**SAN ANTONIO WATER SYSTEM
C-5 CULEBRA – CASTROVILLE TO LAREDO AND C-28 ZARZAMORA CREEK SAN
GABRIEL TO NW 23RD STREET, PHASE 2
SAWS JOB NO. 17-4501
SAWS SOLICITATION NO. CO-00114**

ADDENDUM NO. 6
June 28, 2017

**ADDENDUM NO. 6
June 28, 2017**

SHEET C-A-04
 SHEET 14 OF 57

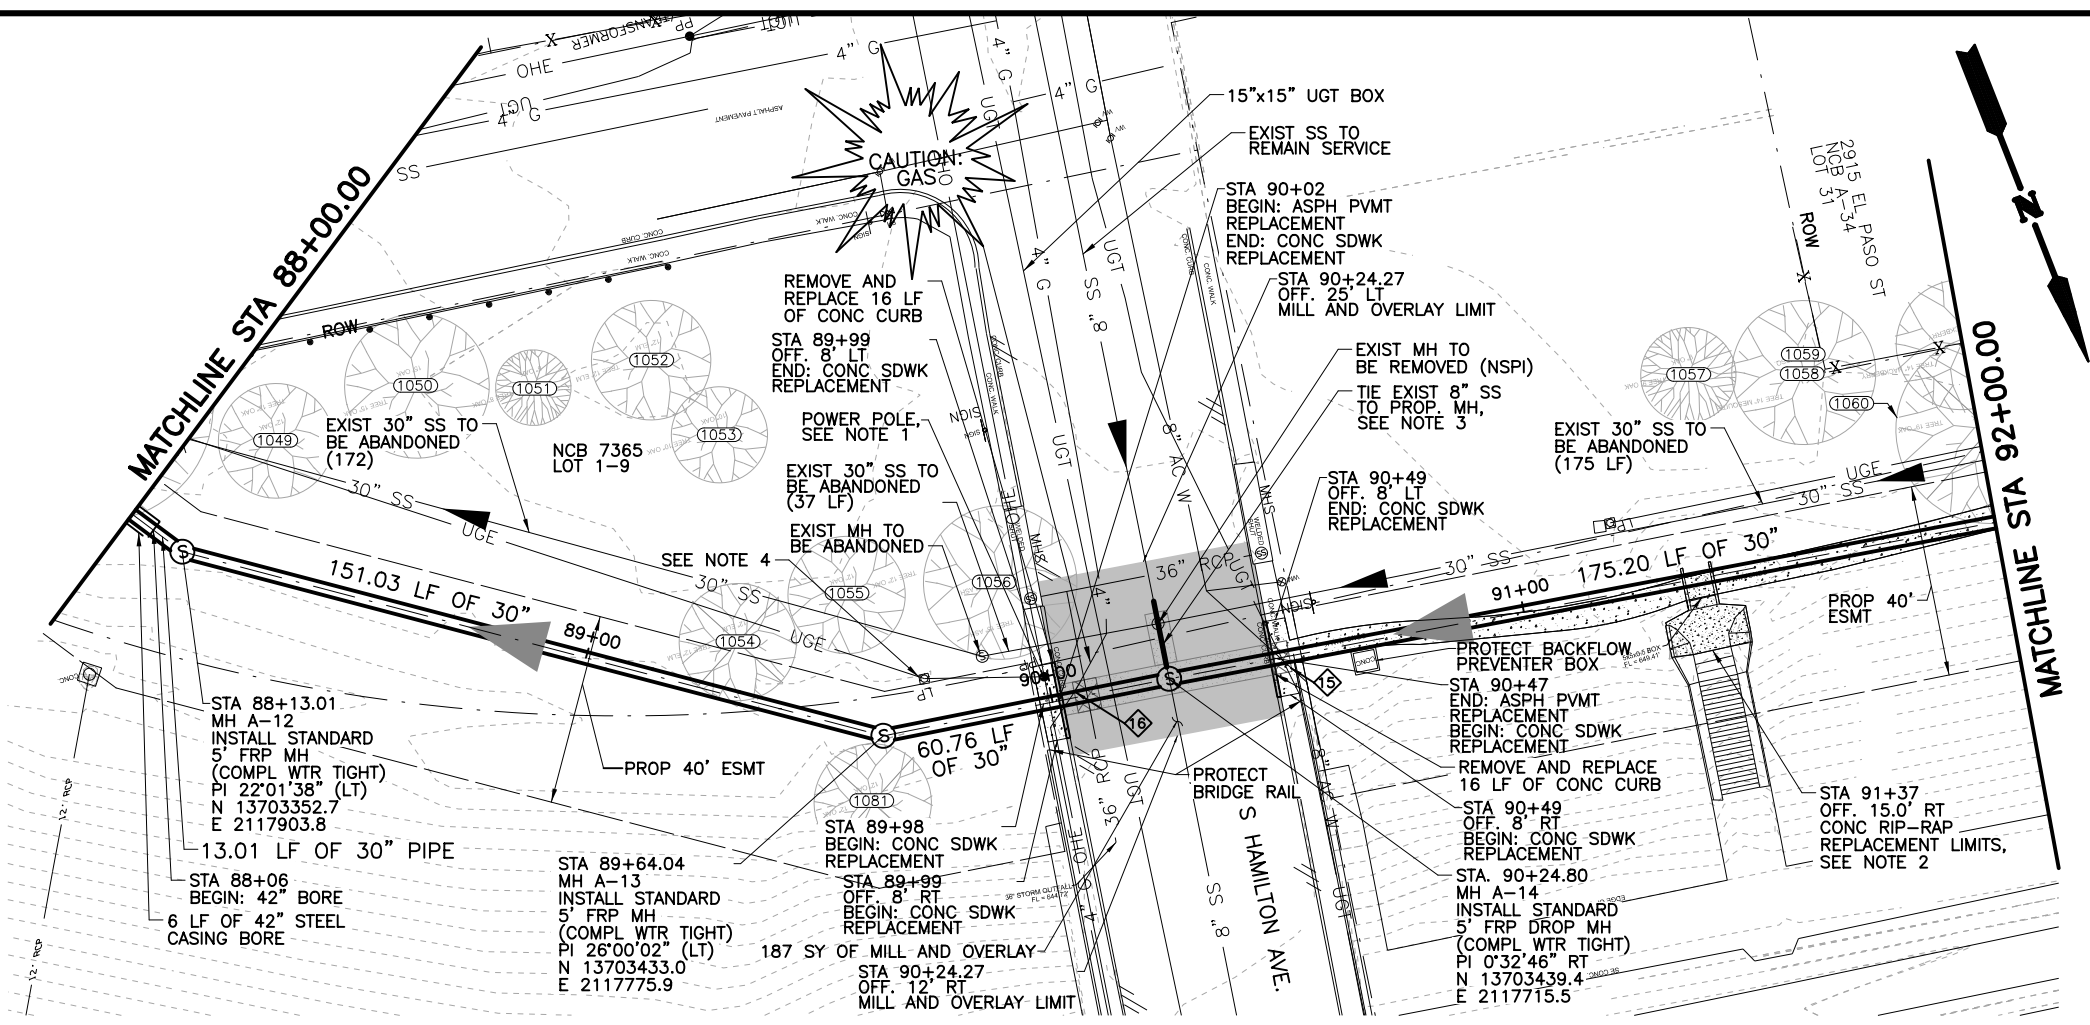
A4: No, there are laterals on the 36” sewer along Nuevo Leon Street. Delete Sheets G-08, C-A-02, and C-A-04 in their entirety and replace them with the revised Sheets G-08, C-A-02, and C-A-04 attached to this addendum.

SHEET C-A-06
 SHEET 16 OF 57

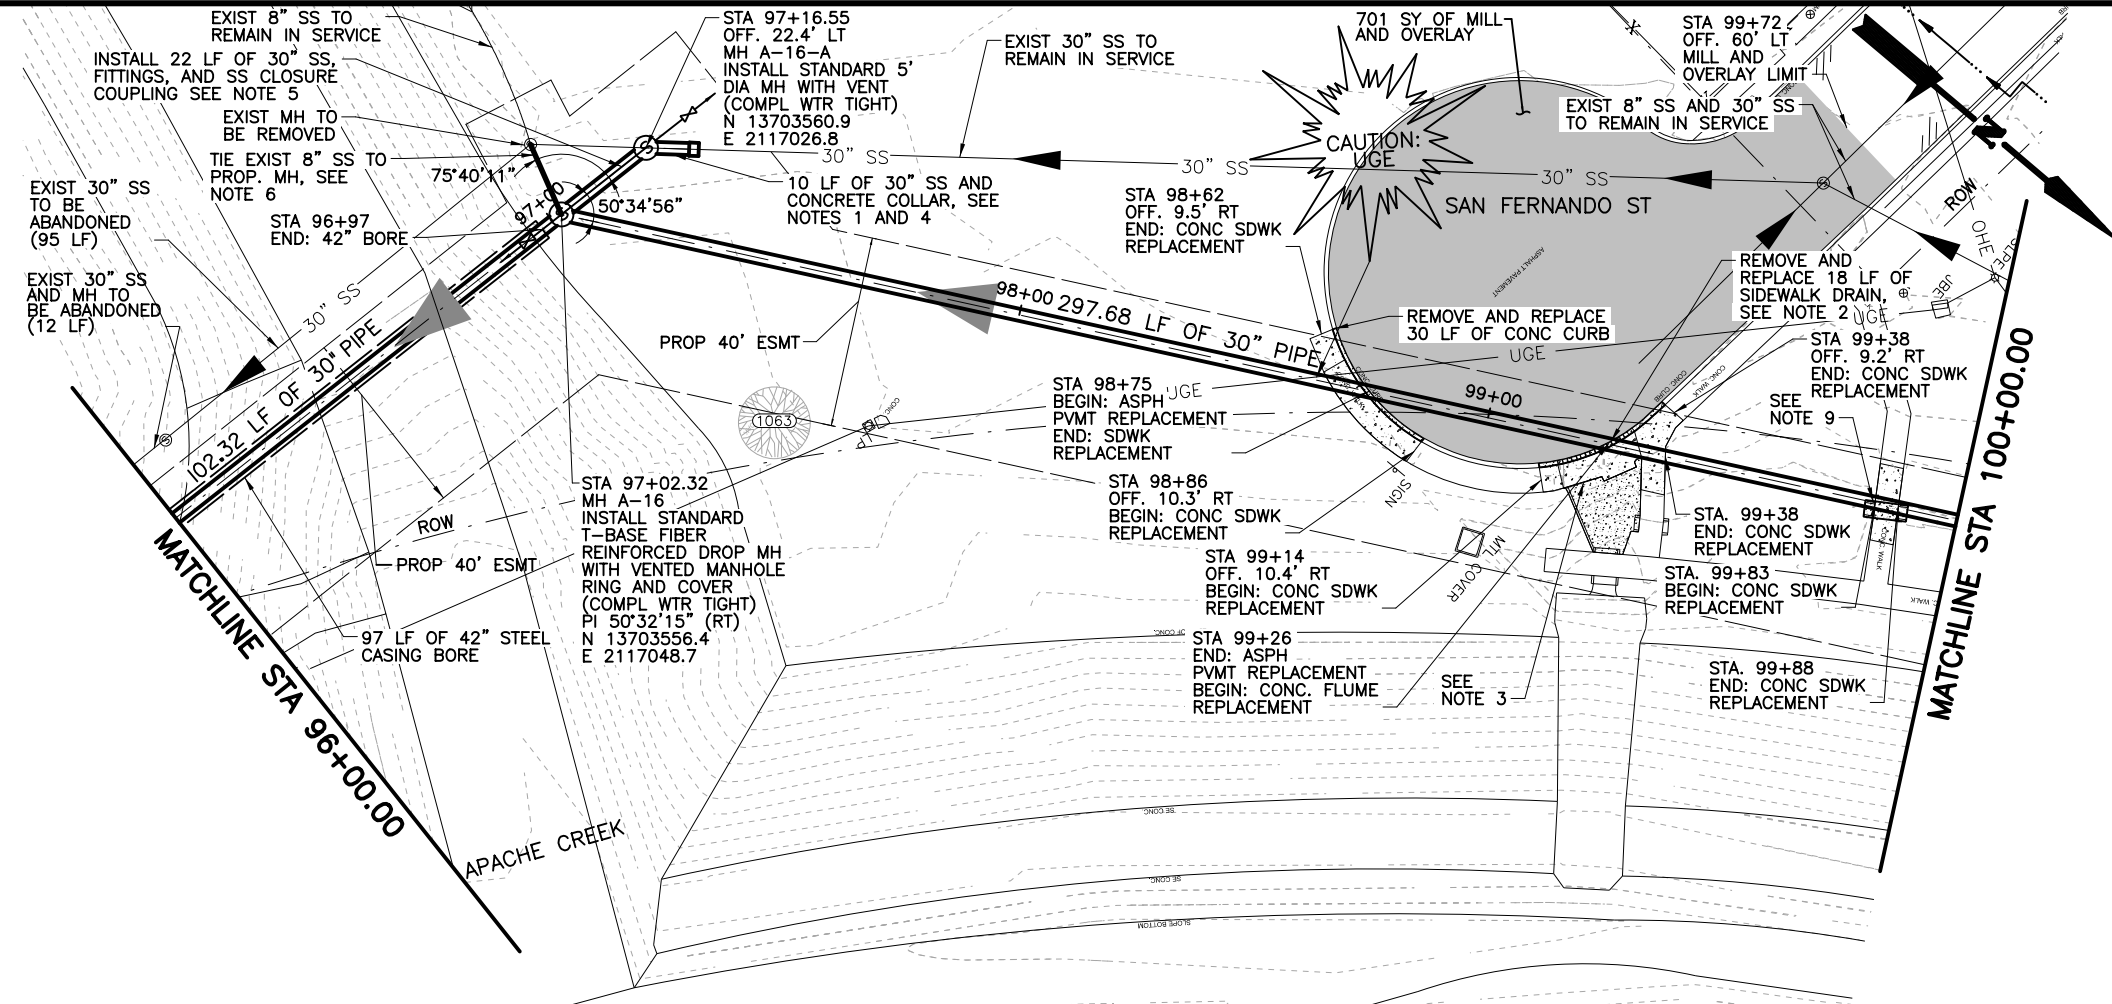
- **Q2: There are no bore pit limits shown on the plans. Will SAWS follow their normal procedure and show the limits insuring there is enough room to complete this work especially at manhole A-11?**

A2: Exact bore pit location and limits are determined by the Contractor as part of their means and methods. The tunnel upstream from MH A-11 is shown on Sheet C-A-06 to begin at Sta. 88+06 and progress downstream to Sta. 87+28 at minimum slope (0.06%),

so the receiving pit will be located in El Paso Street. Per Sheet C-TC-03, El Paso Street may be closed during normal working hours. However, all lanes must be open to the public by the end of the day.

SHEET C-C-01
 SHEET 22 OF 57

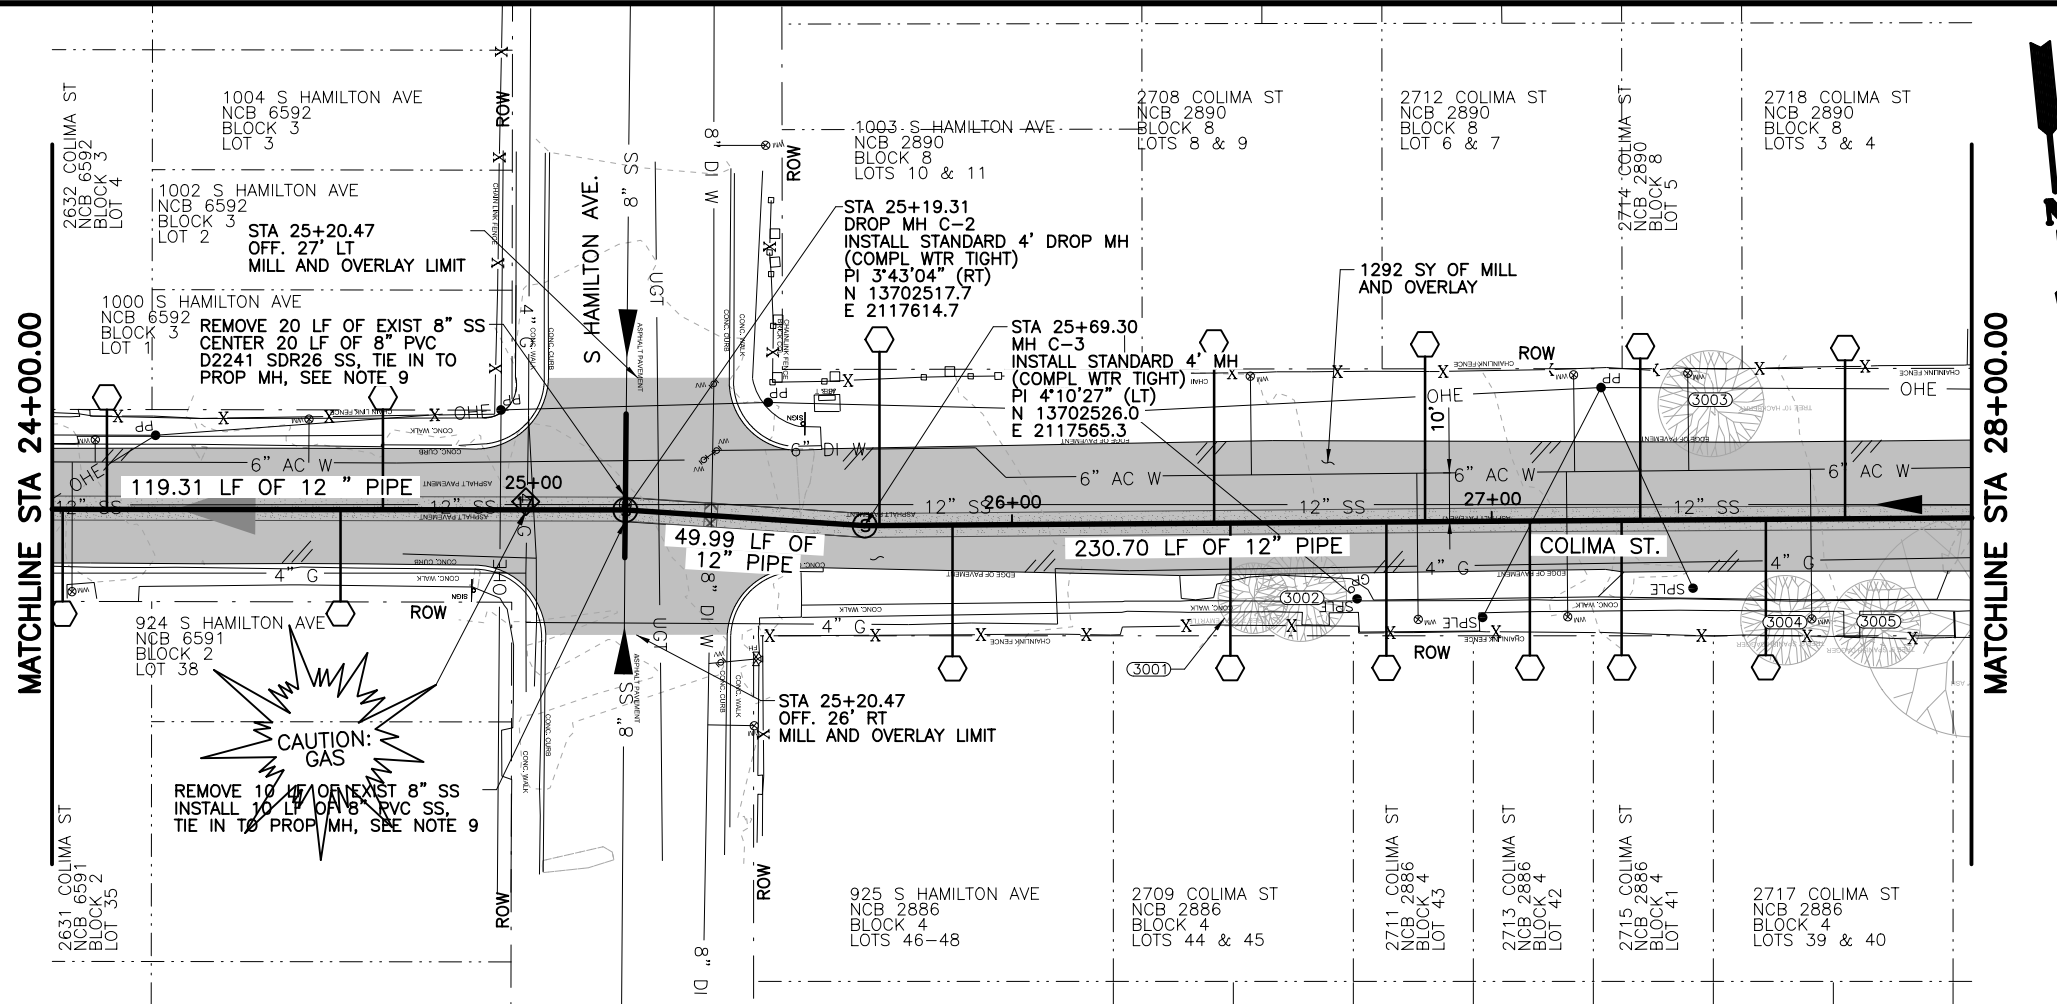
- **Q16: Plan sheets C-C-01 thru C-C-09 call out at approximately 58 locations of 18 LF of 12” PVC ASTM 2241 SDR26, but the bid quantities are only for 90 LF (6’-10’)? How will the contractor be paid for the additional quantities for the 12” PVC ASTM 2241 SDR26 and depths of installation?**

A16: Sheet Quantity Summary tables for Sheets C-C-01 through C-C-09 and Phase 2 Quantity Summary tables (Sheets G-03 and G-04) have been updated. Delete Sheets G-03 and G-04 and Sheets C-C-01 through C-C-09 in their entirety and replace them with the revised Sheets G-03, G-04, and C-C-01 through C-C-09 attached to this addendum. Also, delete the bid proposal in its entirety and replace it with the bid proposal attached to this addendum.

C TRENCH RESTORATION - ASPHALT PAVEMENT
NTS

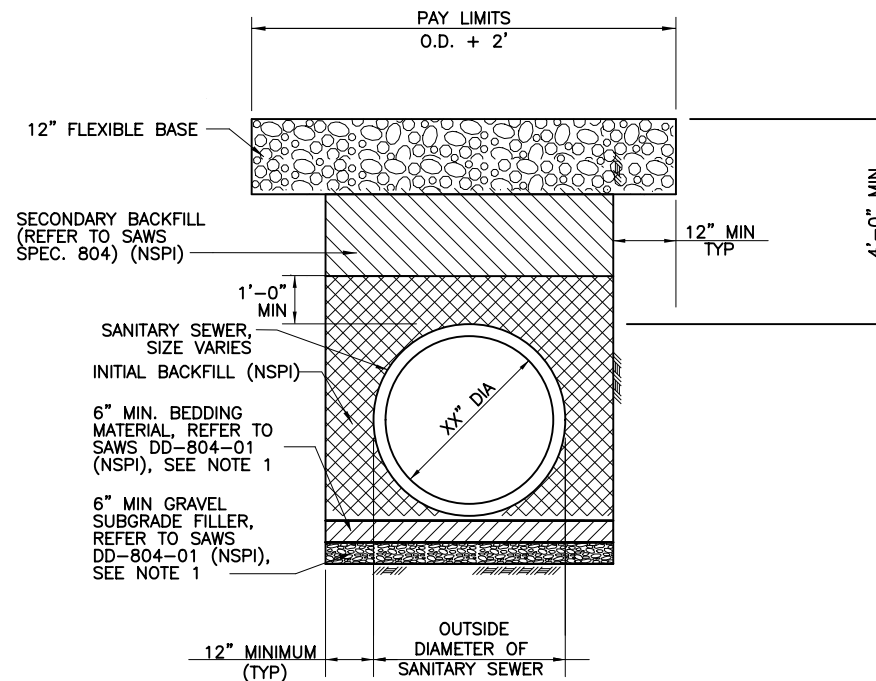
- **Q17: Plan sheet D-02, details for Trench Restoration indicated pay limits O.D. + 2’, but the details also show a 12” Min TYP T-cap at each side of the trench. How will the contractor be paid for the additional 12” Min T-cap for Concrete/asphalt pavement restoration?**

A17: Detail C on Sheet D-02 has been revised to show pay limits equal to O.D. + 4’. Delete Sheet D-02 in its entirety and replace it with the revised Sheet D-02 attached to this addendum.
